551 Fairview - Comments and Heritage Impact Evaluation by the Heritage Committee of the Rockcliffe Park Residents Association

**551 Fairview Avenue, Rockcliffe Park
Proposal for an addition to the house and alteration of the landscape**

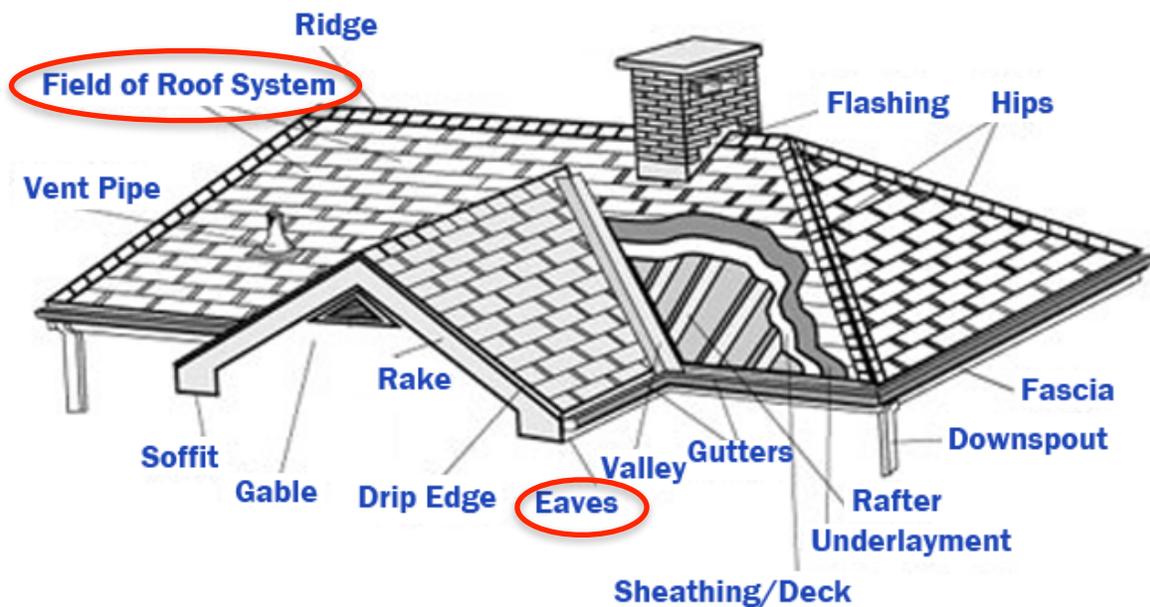
The proposal removes about 48% of the historic material from the East façade and replaces it with contemporary materials. The proposal removes and does not protect the attribute of the predominance of stucco which is identified in the RP HCD Plan. There is loss of integrity to the roof of the Grade 1 building at the eaves line where the proposal pierces the eaves line over a considerable distance, and introduces the projection of a flat roof.

AS SHOWN, THE EAVES LINE AND THE FIELD OF ROOF SYSTEM ARE COMPONENTS OF THE ROOF⁷.
